Product hierarchy no. *				Part no.	SBU	Type / Description	Customer part no.
SBU	PG	PUG	Type				
02	005	016	0000001166	See list below	Connectors	DC11

2 Type of change

Product Change Notification					PCN DC11		
owner	creation date	release date	released by	change order no	rev	page	D10-041-422
huberth	03.12.2019	20.12.2019	muehlema	2018891	A	1 of 2

Old product approval and rating	New product approval and rating

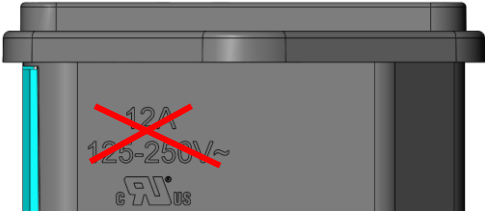
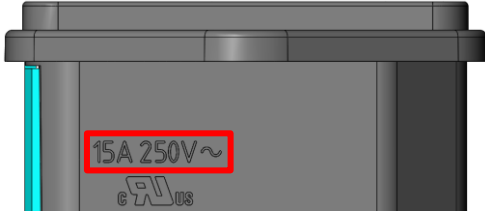
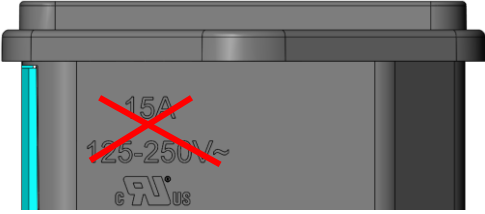
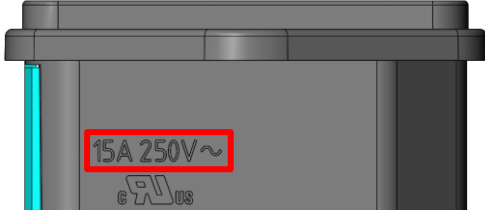
- Rating for VDE and CCC according IEC 60320-1
- Rating for UL new 15A for all variants

old 12A-Variants	new valid up to 15A

15A-Variants

The change is due to a standard update to UL/CSA 60320-1.
